Response to Submissions and Statement of Commitments

23 Scrivener Street, Warwick Farm
Project Application No. 08_0088

Submitted to
NSW Department of Planning
On Behalf of Independent Print Media Group Pty Ltd

January 2009 ■ 07546

Revised Drawing (SK.02)

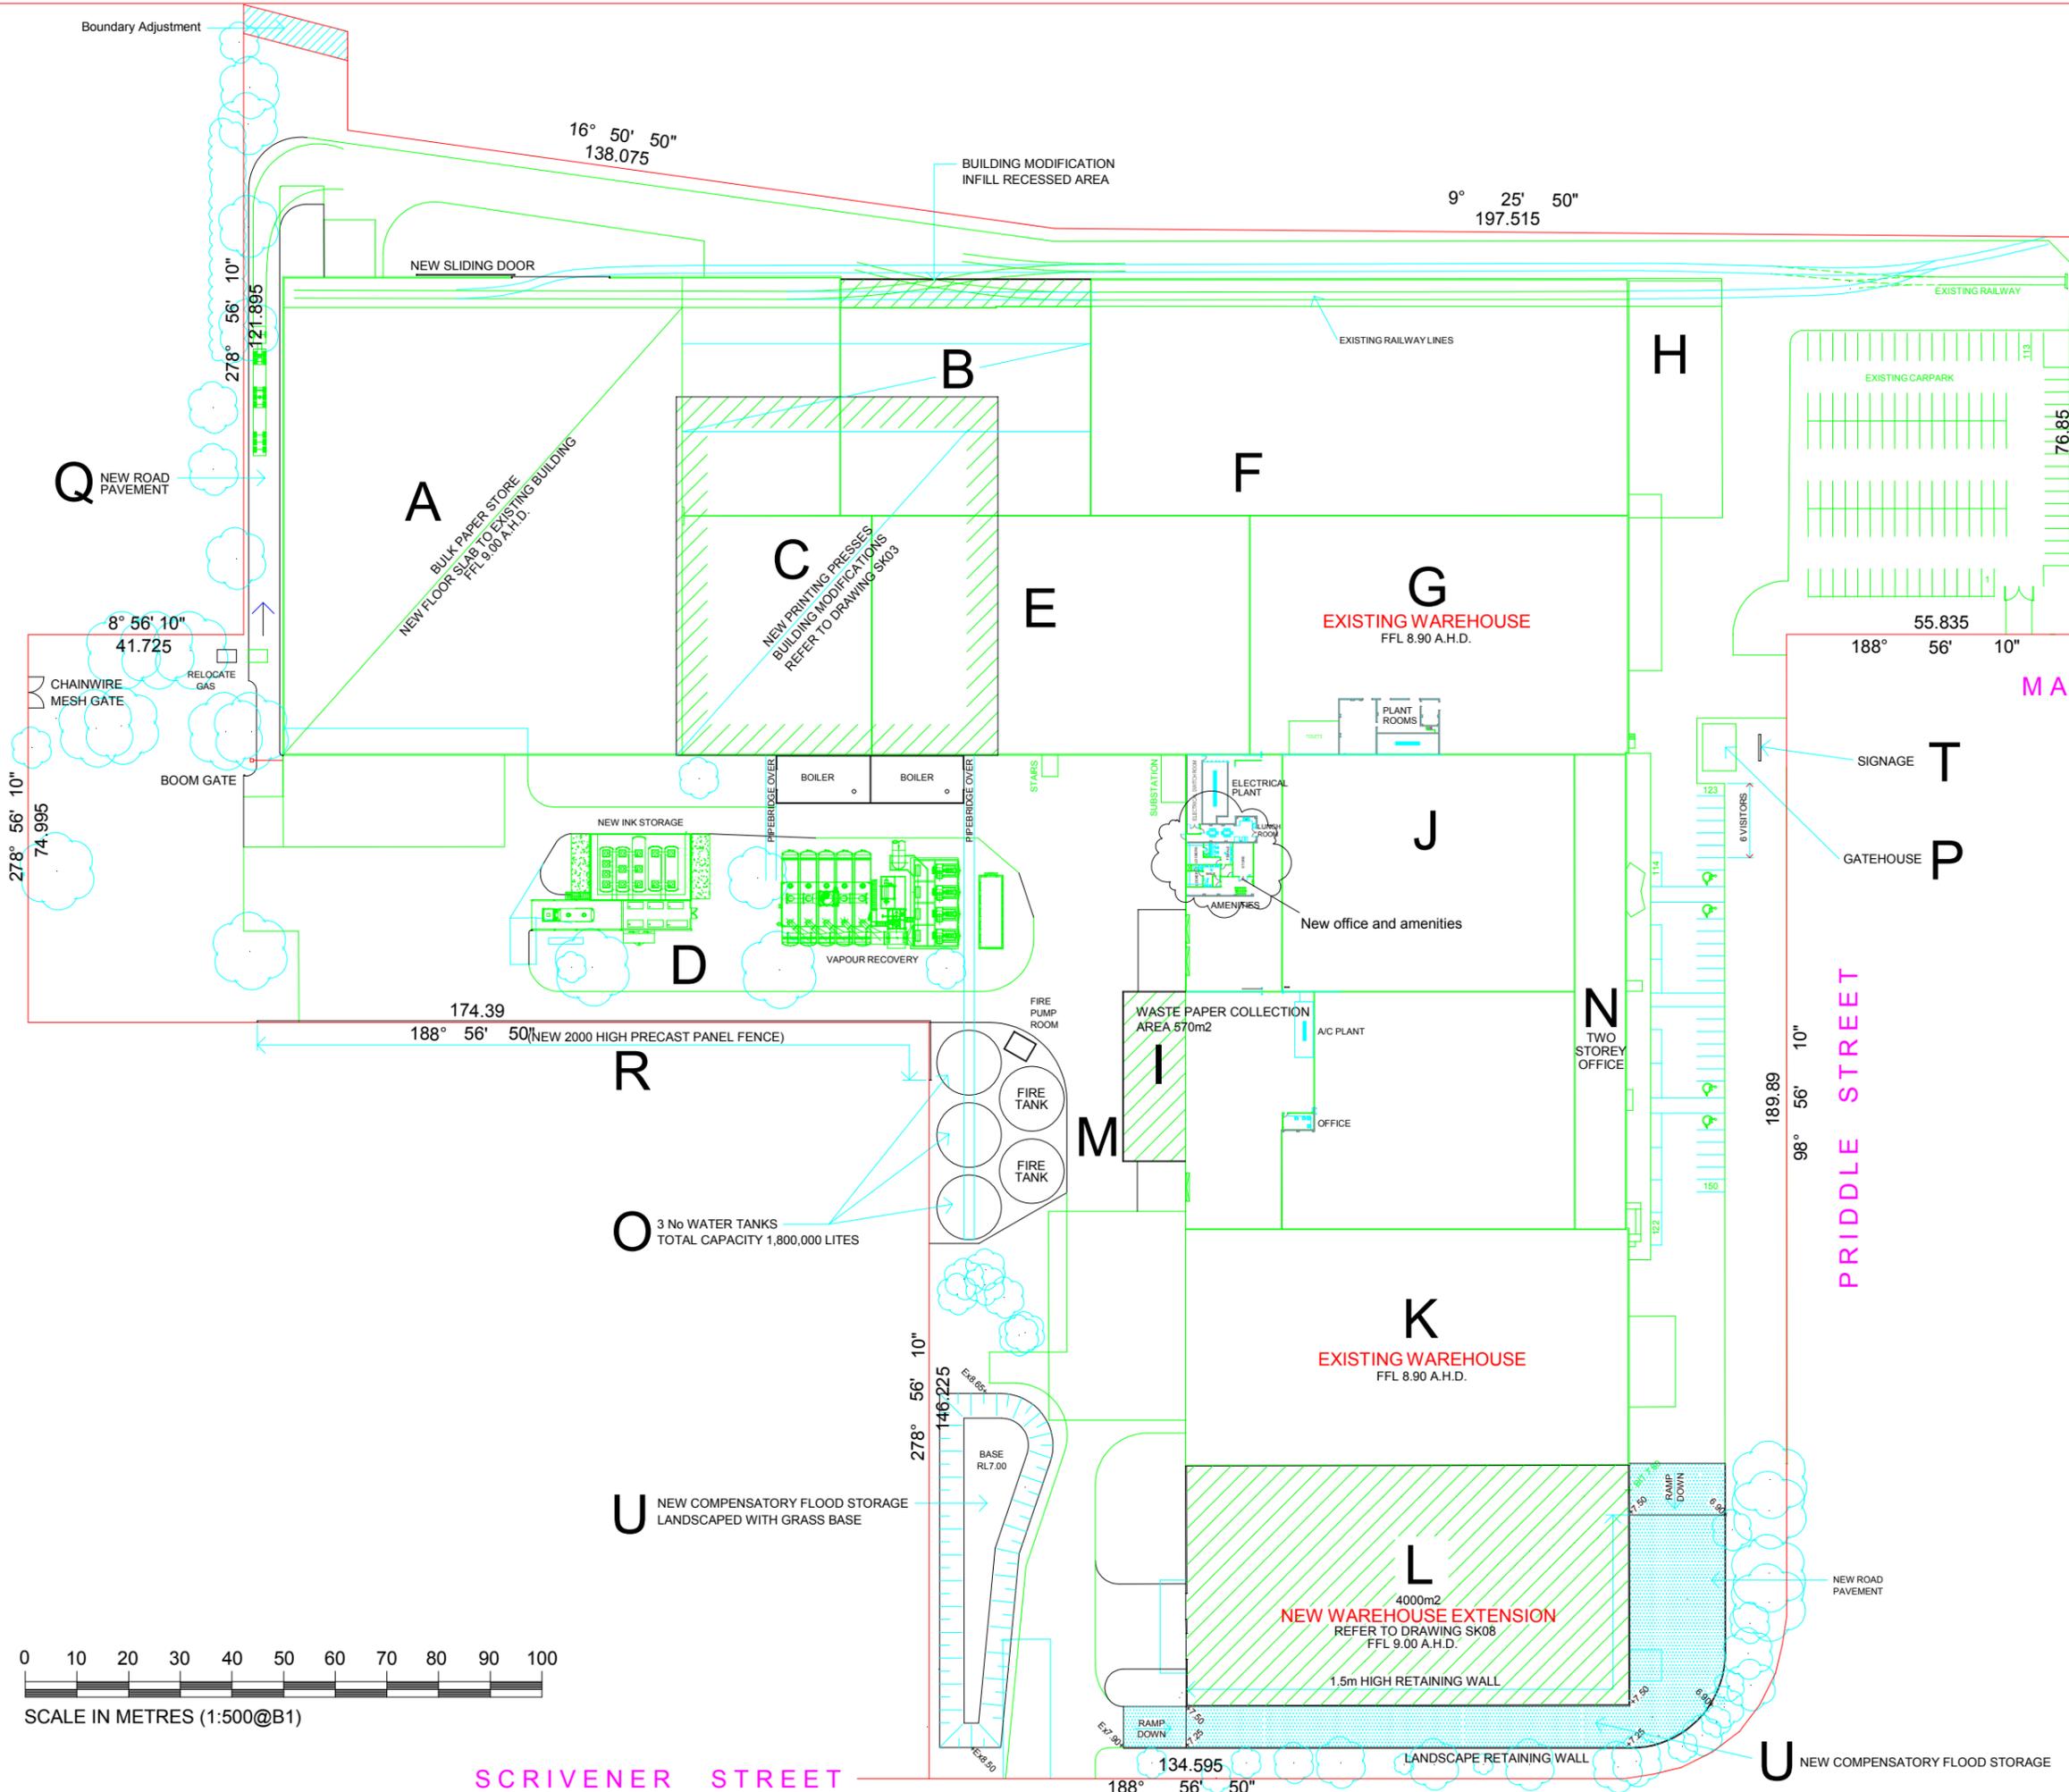
This report also replaces engineering drawing SK.02 of Appendix C of the EAR in order to correct a minor drafting error (see **Attachment B**).
